GASCI input to AIC 002/21 – Review of Irish Airspace

On 25 Feb 2021, The Irish Aviation Authority, as the statutory body responsible for airspace design, announced a review of Irish airspace via AIC 002/21 to:

Airspace Concept Workshop 3

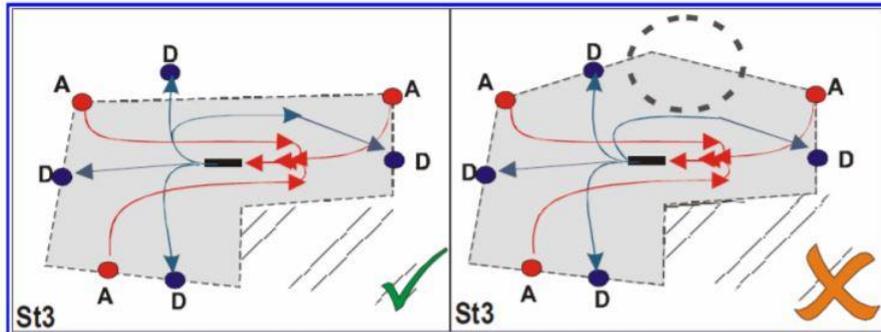
The principle of ***'taking only what is required'*** is re-emphasised in this graphic.
